CLIVE PLANNING & ZONING COMMISSION

RE: Site Plan- Summit Settlement Services- 16363 Holcomb Avenue

Re: 16363 HOLCOMB CT - Summit Settlement Services - Site Plan

SITE PLAN
LOT 2, BERKSHIRE COMMONS OFFICE PARK
16363 HOLCOMB CT
CLIVE, IOWA

UTILITY PLAN

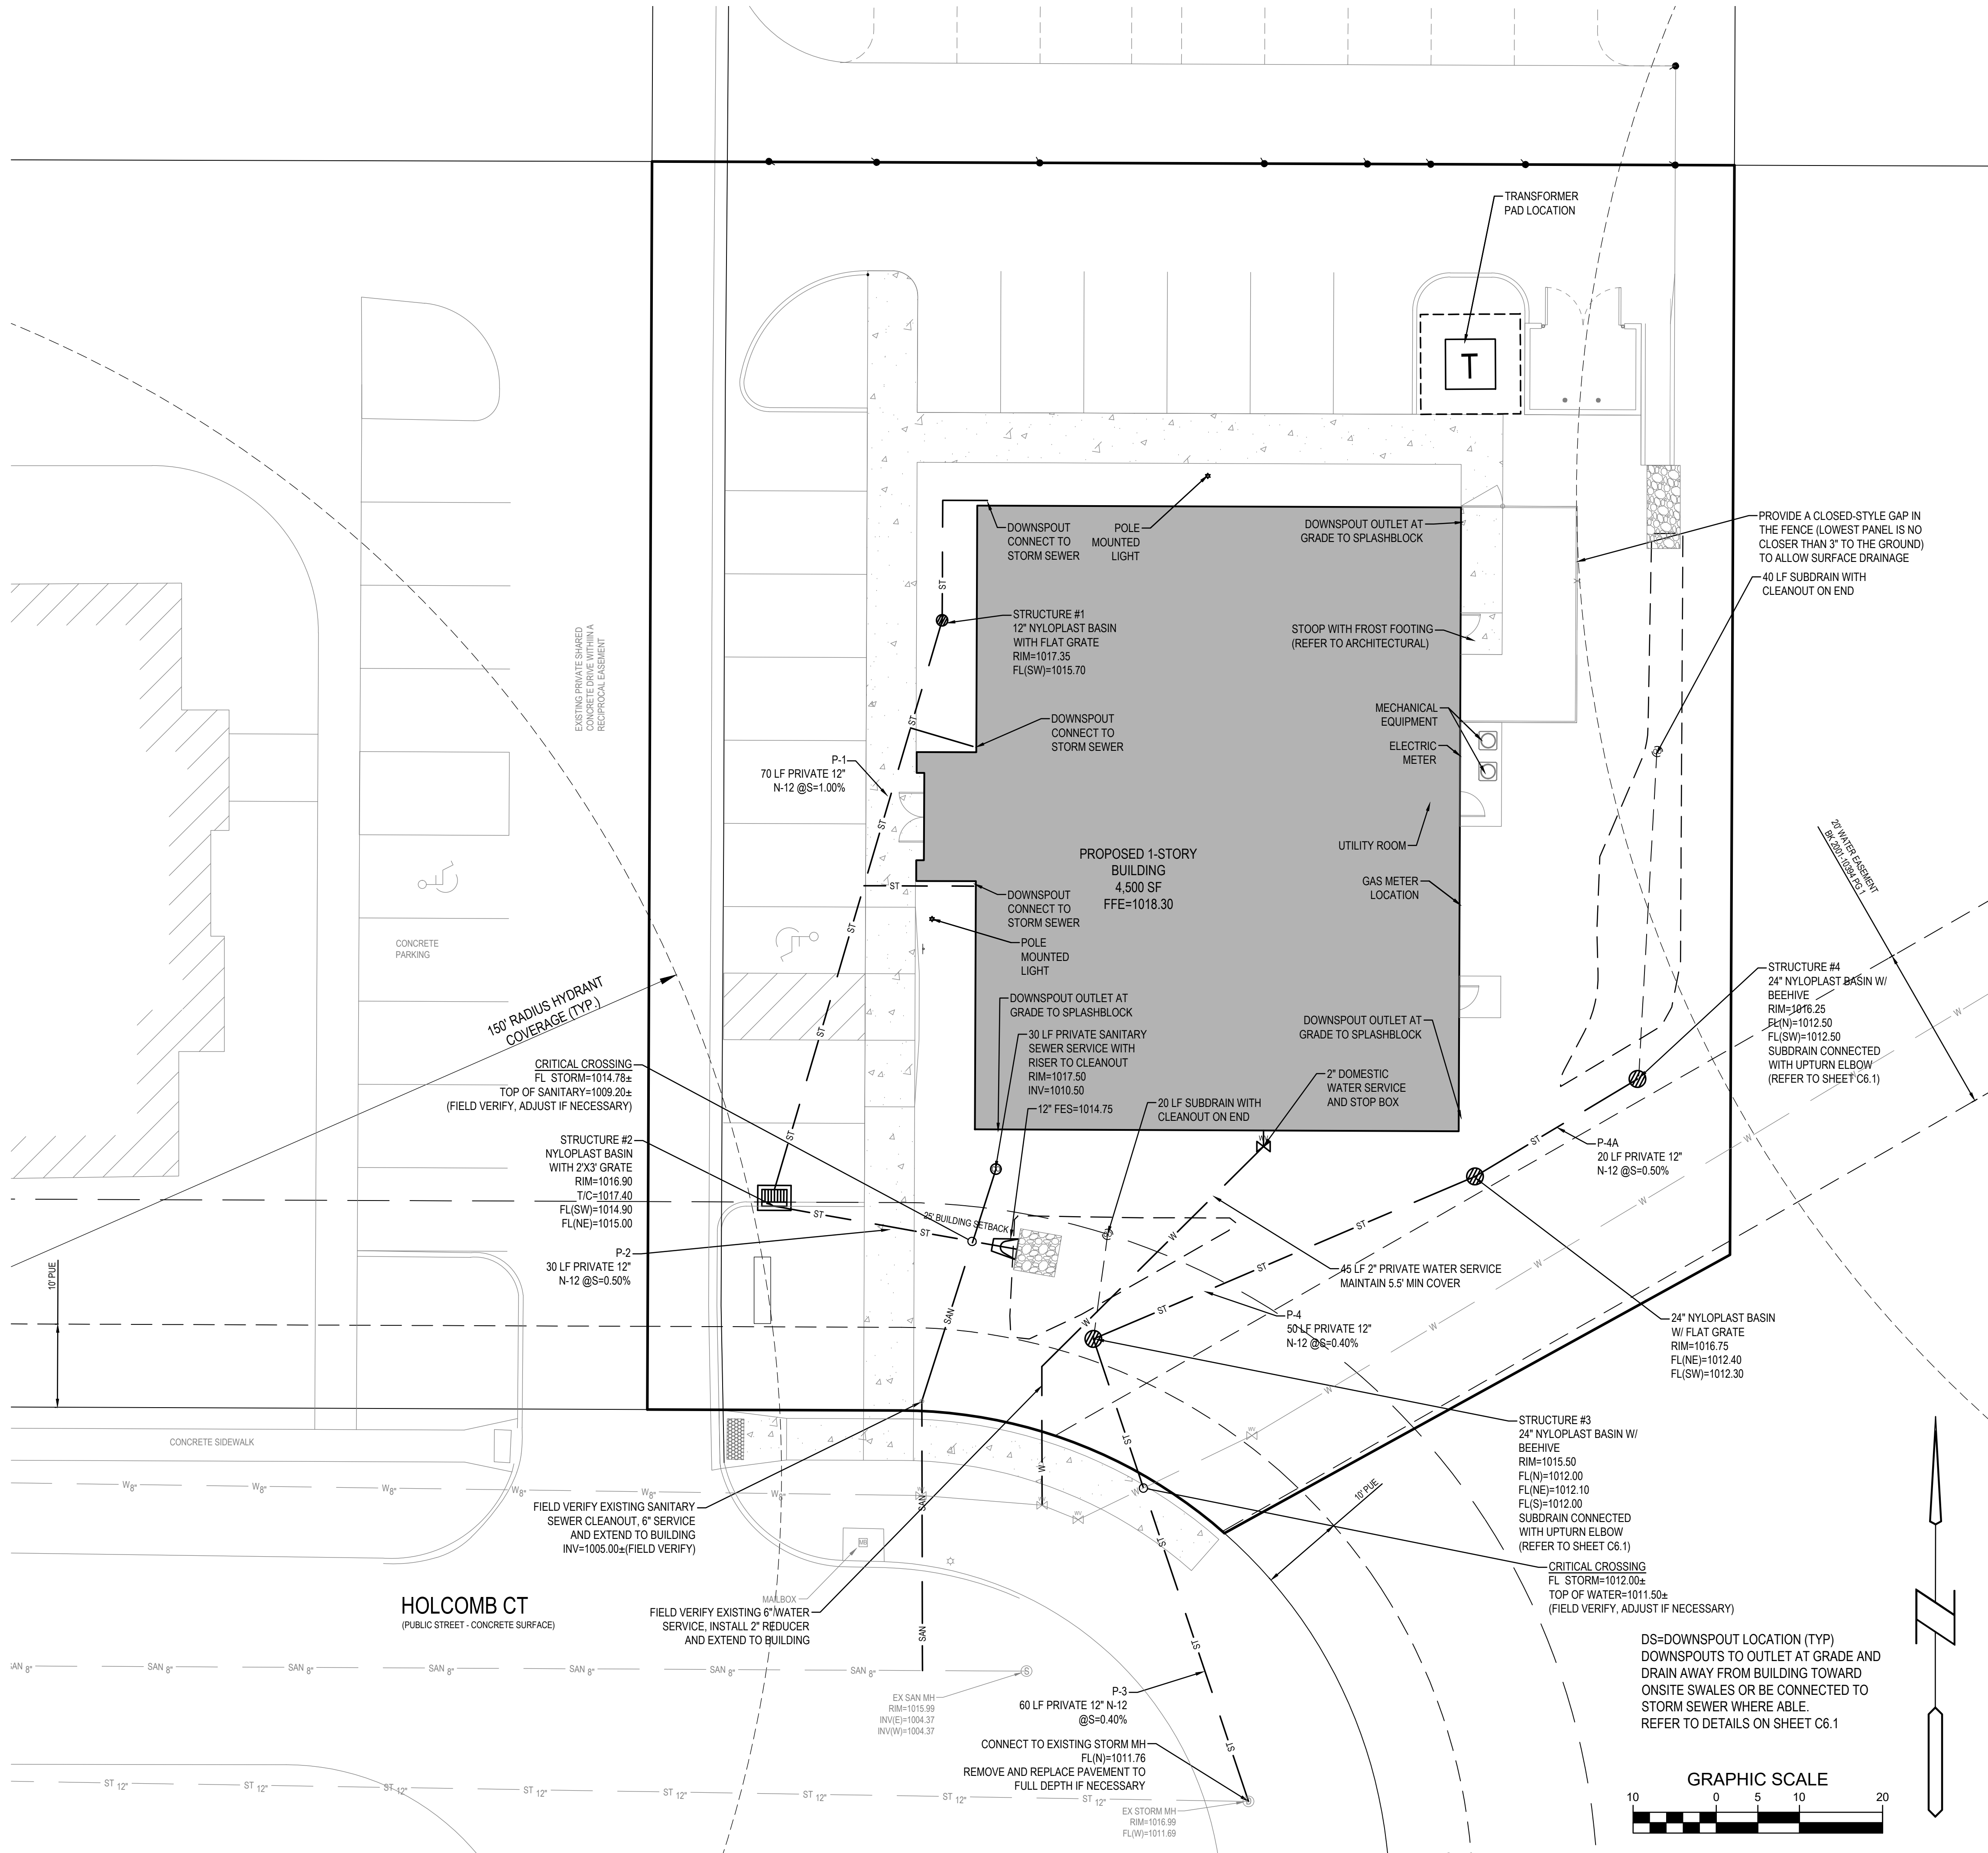
1. please exchange the photocopies of the development standards to typed editions of Appendix E and F integrated into the utilities page.
2. Update documents so that SWMP and plan set match:
-- P4A is 0.4% in plans and calculations in SWMP are for 0.5%
3. A replacement structure is not shown. Demonstrate that a 12" RCP to 12" RCP with less than 90 degrees between will remain structurally sound.
4. Staff notes the change in proposed size from 15" to 12" N12 pipe. Pipe within the right-of-way must be concrete to withstand other right-of-way work (for example, water main breaks, installation of new pipe, or road reconstruction).

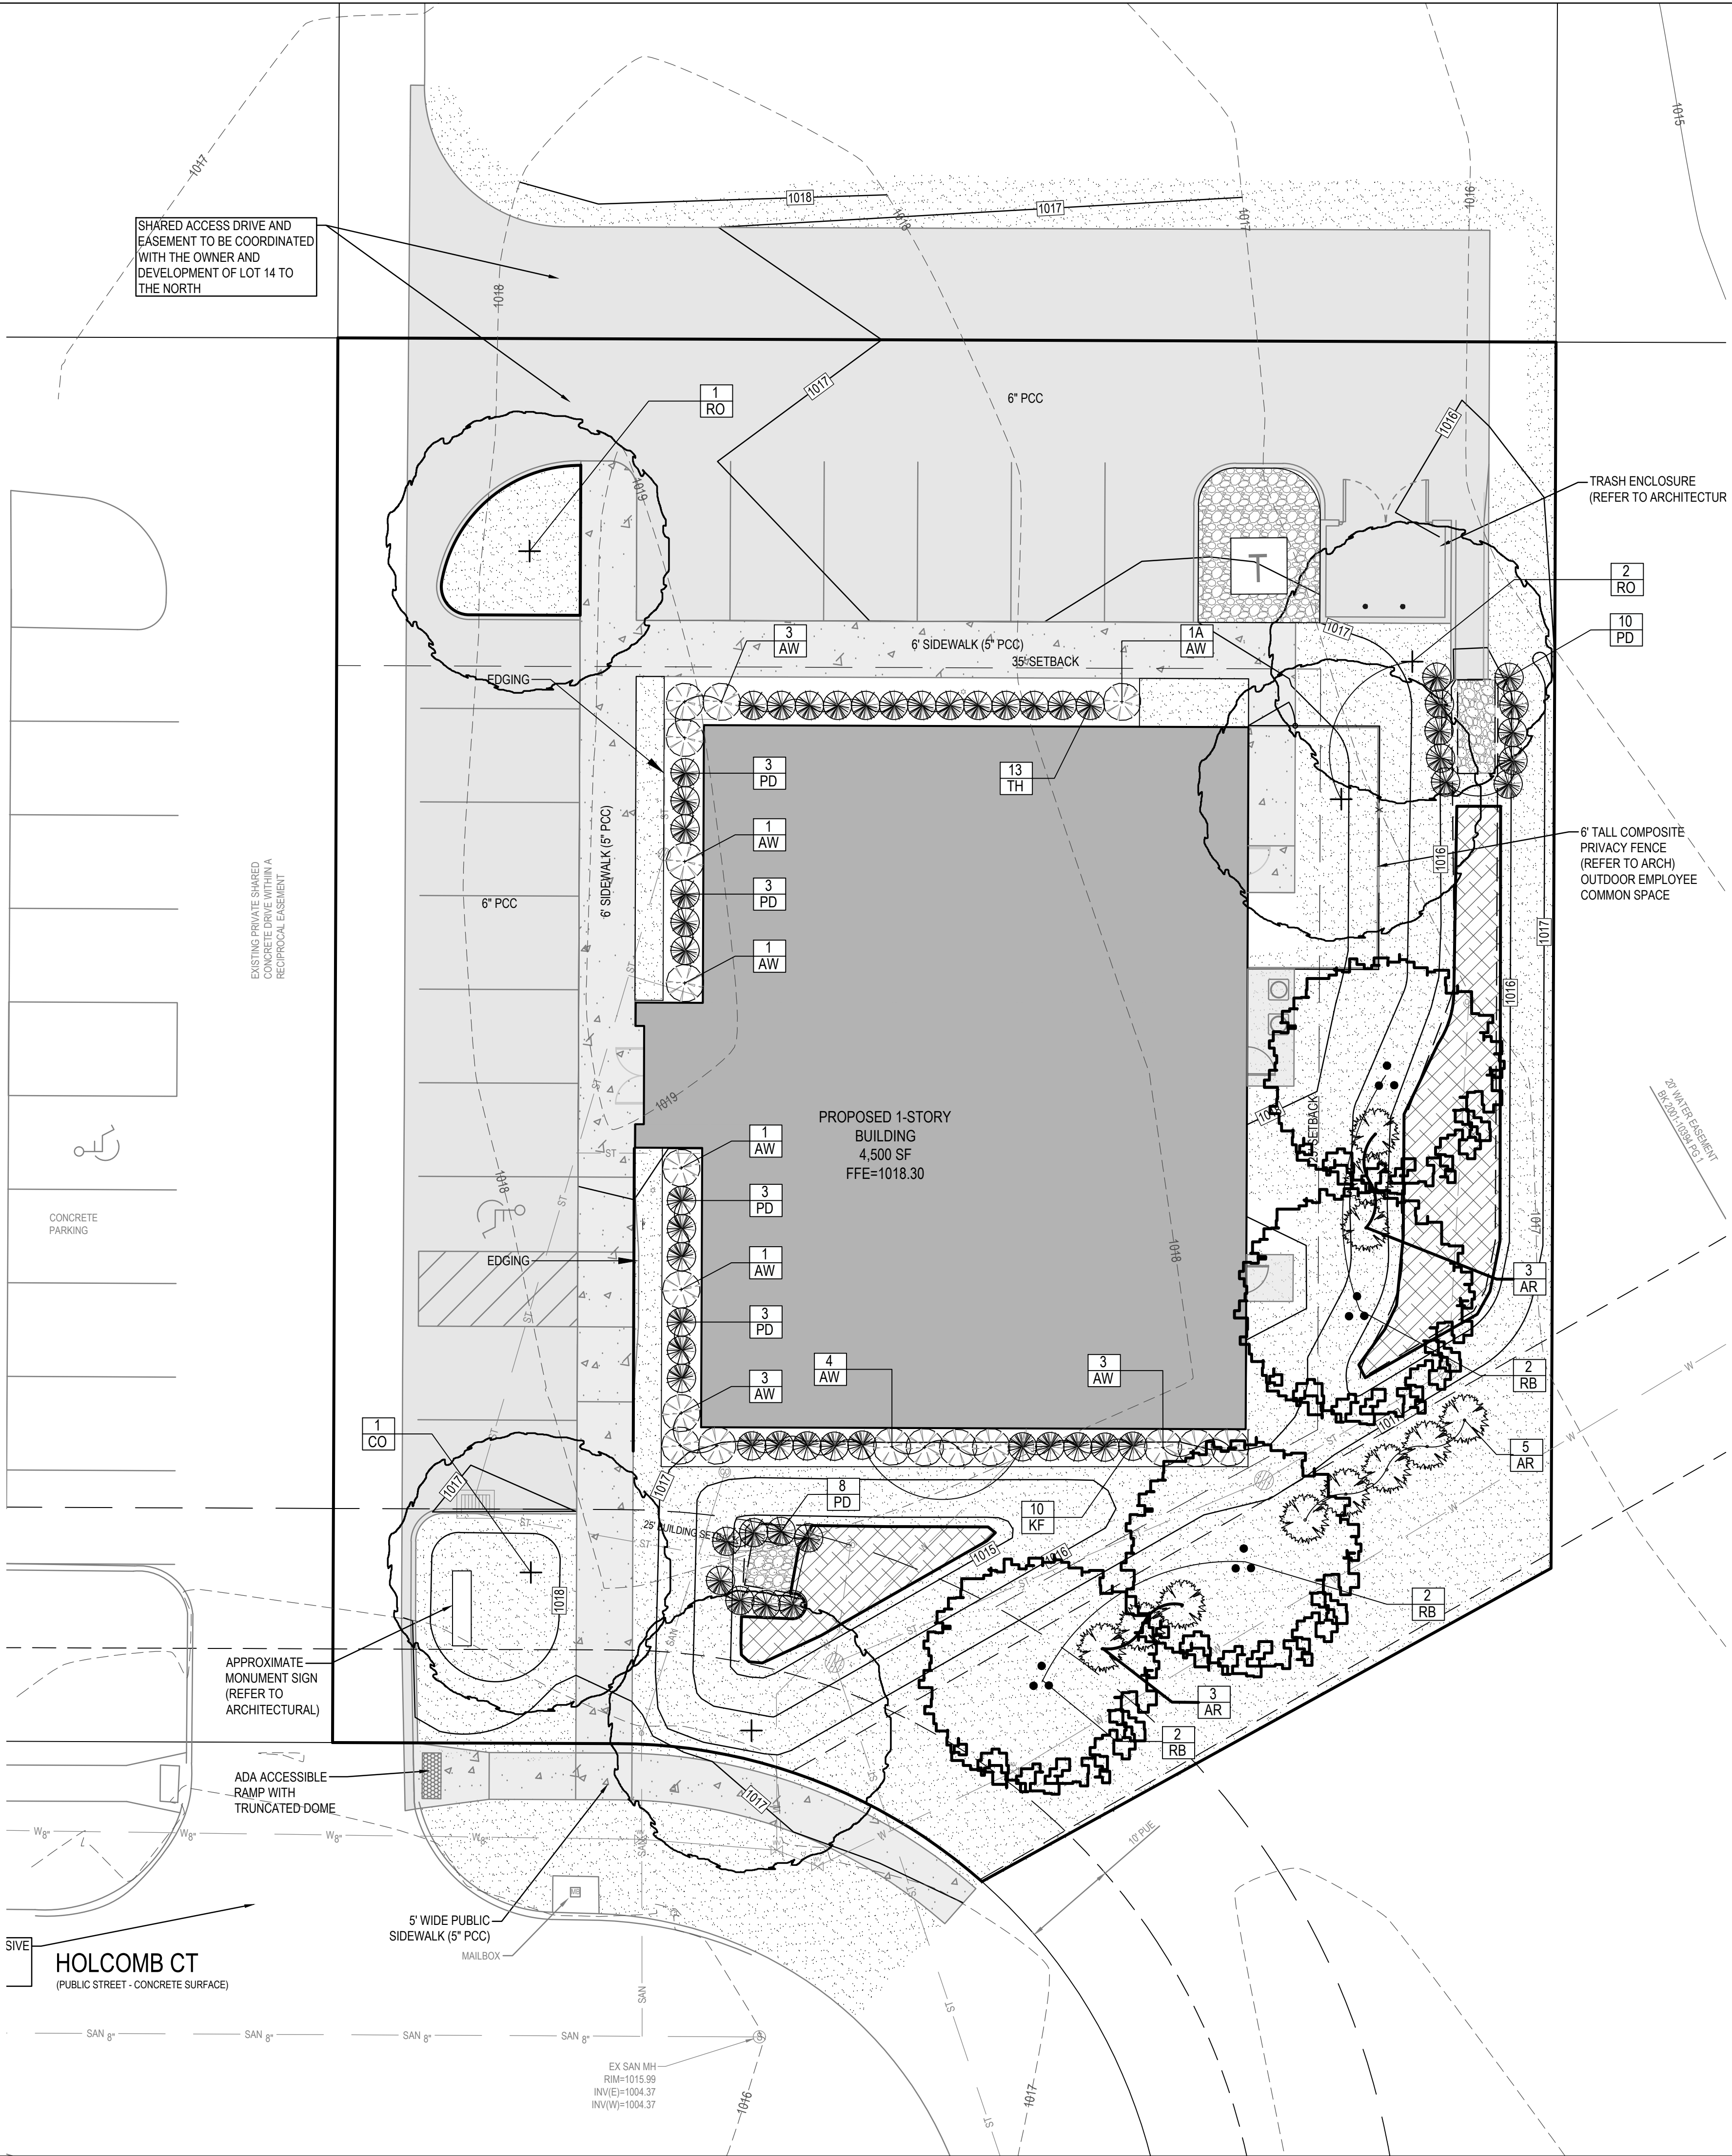
1. Please extend some of the foundation plantings to provide screening for the mechanical units and pad on the east side of the building.

SHEET NAME:
SOIL
MANAGEMENT
PLAN

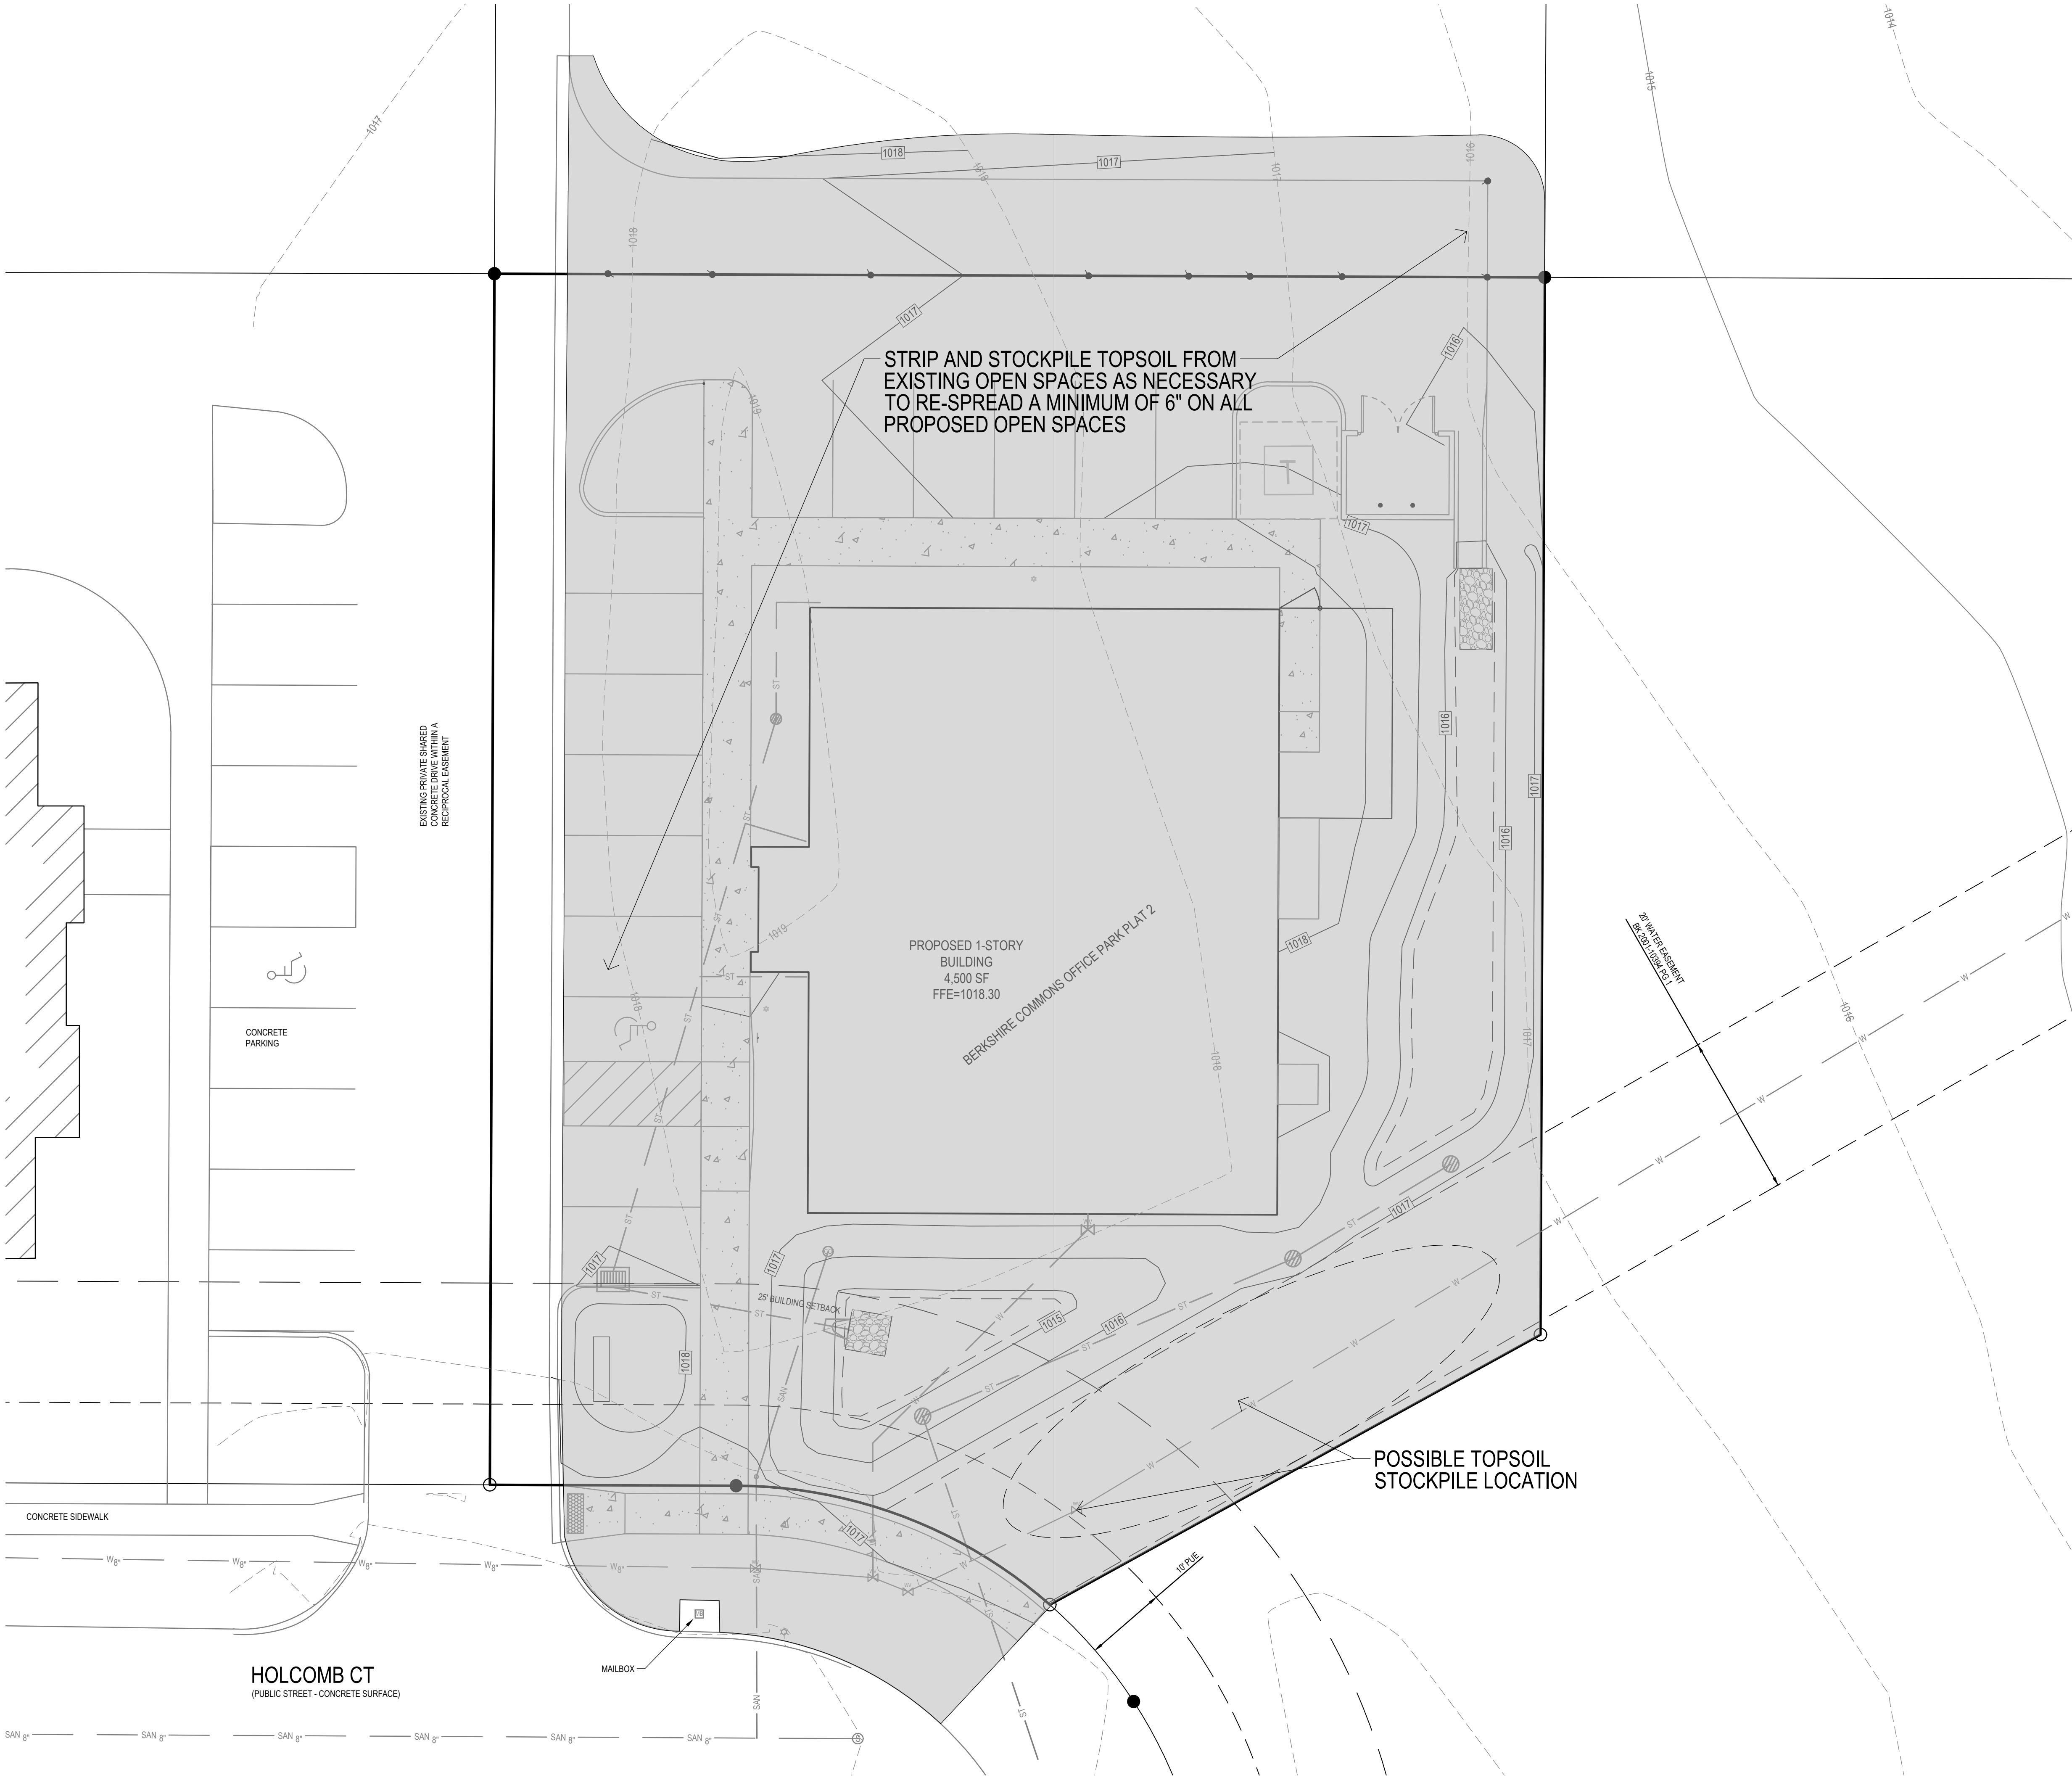
1. Note 21: State the minimum organic content as a single number. That number should match the SWMP, but since the contractor will not be referencing the SWMP during construction, this value needs to be explicitly in the plan set.
